# ENVIRONMENTAL REVIEW TEAM REPORT

## BRONSON ROAD SUBDIVISION PROSPECT, CONNECTICUT

**BRONSON ROAD SUBDIVISION  
PROSPECT, CONNECTICUT  
OCTOBER, 1982**

FIGURE 2. SITE PLAN

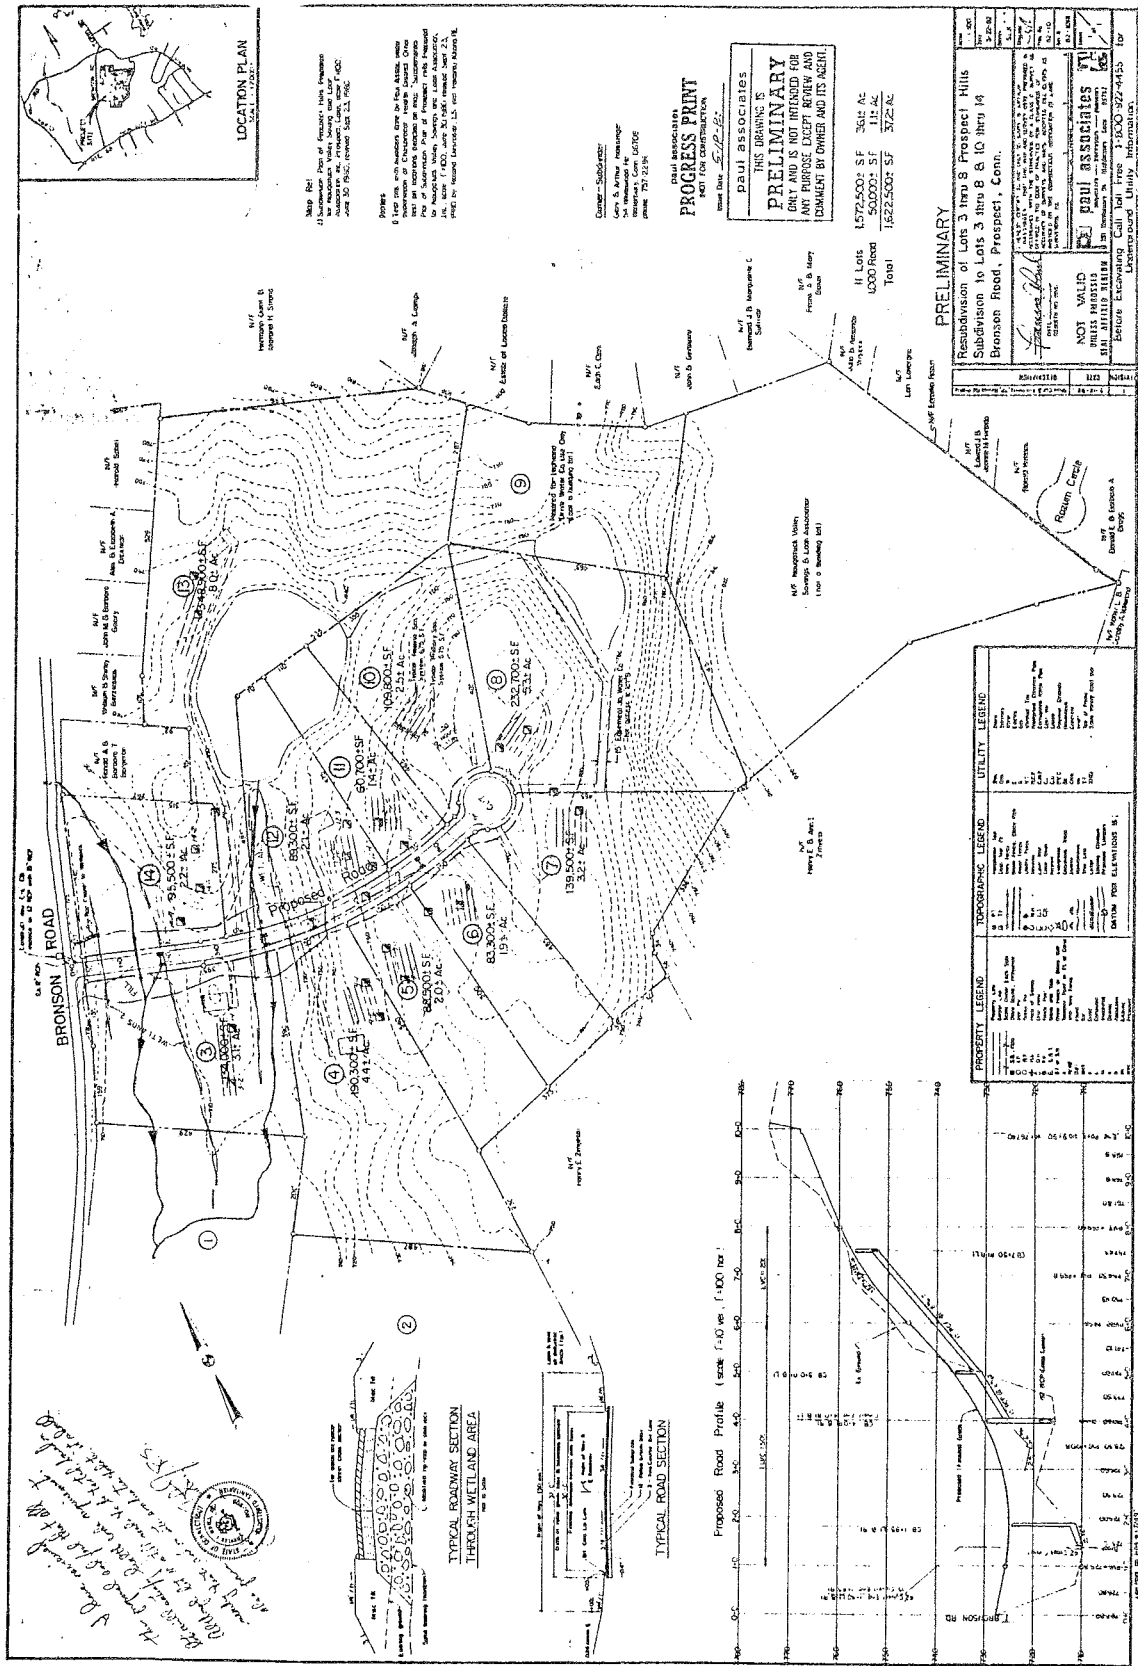
Special consideration and protective measures should be used in regards to the proposed roadway where it crosses the wetland areas in the front 525' off Bronson Road. The proposed road profile on the preliminary plot plan, dated March 22, 1982, calls for as much as 16' of vertical fill. With minimum side slopes of 3:1, this will mean an area 128+ ft. wide through the wetland area.

Sedimentation and erosion control measures should be installed in this area before any filling and the embankment slope should be stabilized immediately after final grade is reached. Stabilizing can be accomplished by permanent grass seeding and mulching of entire embankment area.

The wetland area that is located in lots 8 and 9 should also be protected from sedimentation during the development of this site. This is an undisturbed wetland area that should be maintained for its aesthetic value as well as its stormwater retention capabilities.

The wetland area located in parts of lots 10, 11, 12 and 13 has a significant amount of open water surface area. Protection from sedimentation of this wetland area is needed during site development.

In reviewing the proposed access road to the house location in lot 13 it appears that this roadway will run very close to the edge of the wetland/pond. At this point there is a bank along the wetland/pond several feet in height. Careful design of the road in this section is needed to both stabilize the area from erosion during construction and maintain enough area for access between the property line and the wetland area.

Parcel #9 as shown on the subdivision plan presently serves as a well site for the Highland Drive Water Company. This low yield well is located north of the pond discharge identified on parcel #9. This well location should be accurately shown on plans and provisions should be made prior to subdivision approval to assure the protective well radius will be preserved. If necessary, easements may be filed on the town land records for adjacent properties in order to protect the well. One other area of concern was the sewage disposal system shown on lot #13. Both test pits were left open and exposed soils appeared suitable for leaching system installation. There appears to be sufficient area for leaching system installation further from the existing pond which would provide additional protection to ground and surface waters. A sewage disposal system on this 8 acre lot could easily be constructed in an area beginning from the furthest test pit from the pond and extending westerly, paralleled with the contours. This would maintain the leaching system approximately 60 to 70 feet away from the high water mark of the pond.

VEGETATION TYPE MAP

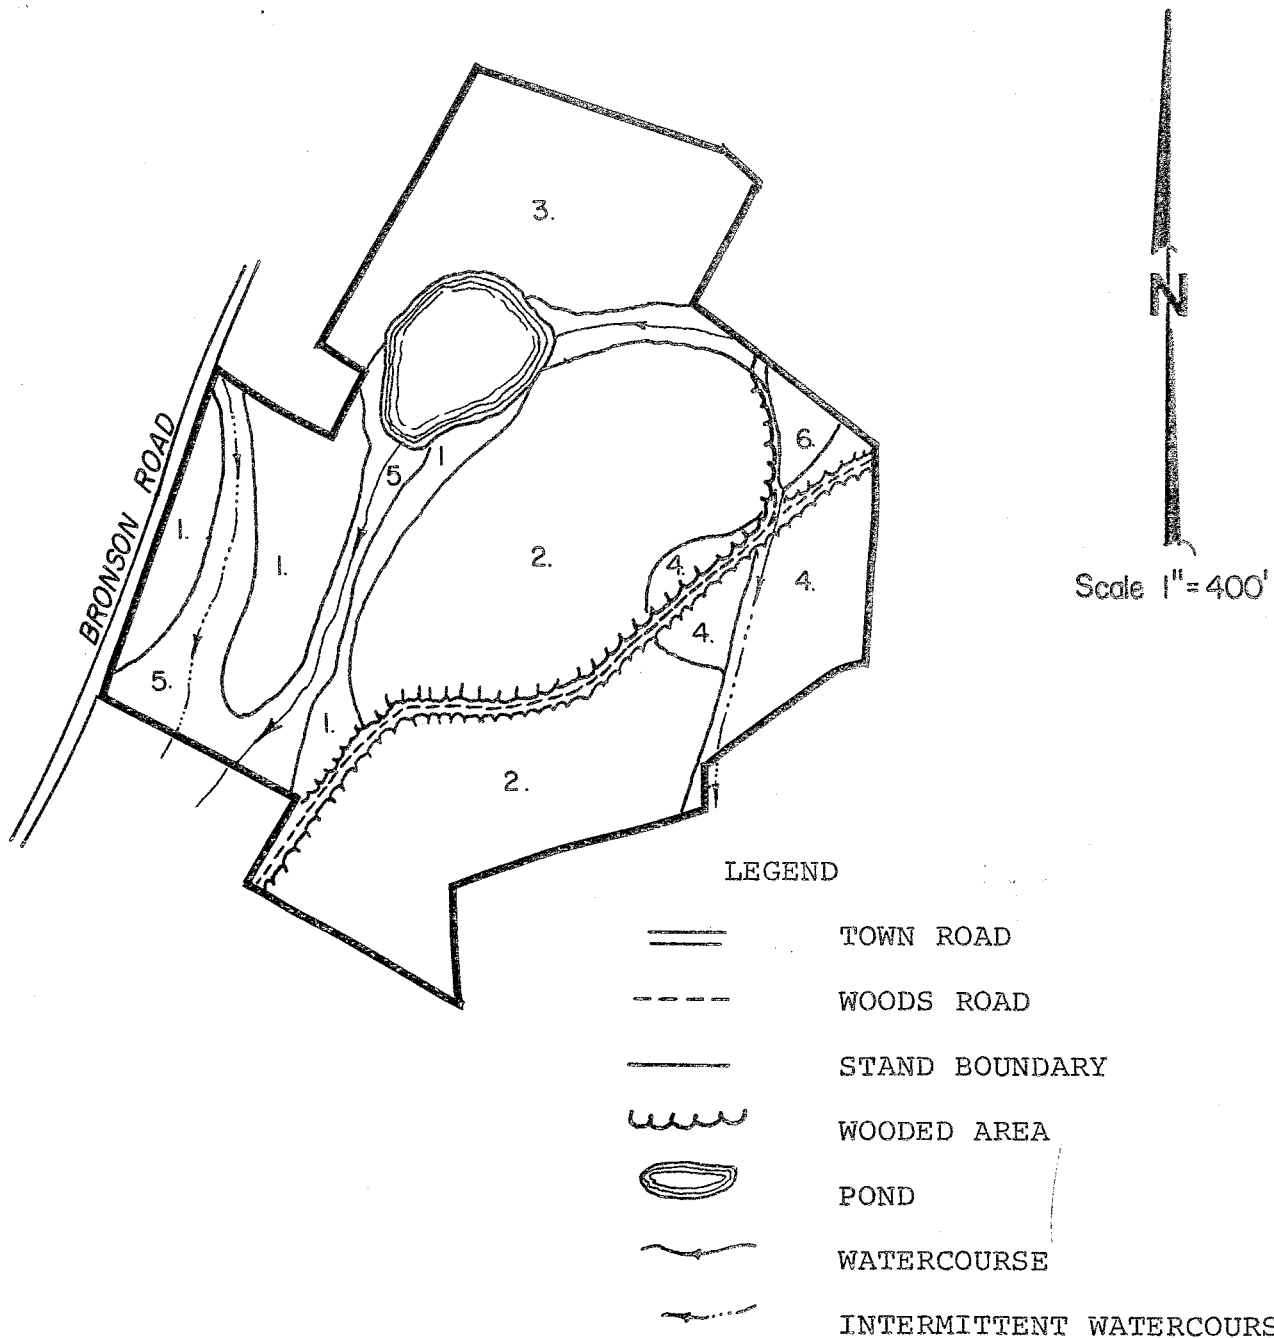
Both types 1 & 3 are at a stage in which they would benefit from a fuelwood thinning. A thinning which removes approximately one-third of the trees in the overstory would reduce competition between residual trees for space, sunlight, nutrients, and water. Within a few years the residual trees will respond with more vigorous growth, would be healthier and, therefore, more able to withstand the effects of disease, defoliation, and adverse weather. Where these trees will be in a residential setting, this will be an important asset to future homeowners. Only the poorest quality stems should be removed in this thinning. This would include severely damaged stems, stems with very small crowns, large seams, and obvious disease problems; and stems which are directly competing with desirable high vigor, healthy trees. The thinning in these areas would probably yield between 4 and 6 cords of fuelwood per acre.

Type 2 would benefit from a light thinning, removing approximately one-fourth of the overstory trees in an operation similar to the one proposed above. This is not imperative and, owing to the smaller size of the trees, the yield per acre of 2 to 2.5 cords may not be tempting enough to interest a buyer.

Types 5 and 6, owing to their high water table and organic soils, are probably not able to support activity by machinery in a thinning operation. In these areas, it is preferable to conduct a light thinning of only what is accessible via cable or foot traffic from the safer confines of drier, firmer soils.

The development of this tract will involve clearing and grading much of the mixed hardwood stand (vegetation types 1 & 2). Located throughout this stand are several healthy trees which have high aesthetic and shade value. These trees should be worked into the landscape plan for this proposal where ever possible.
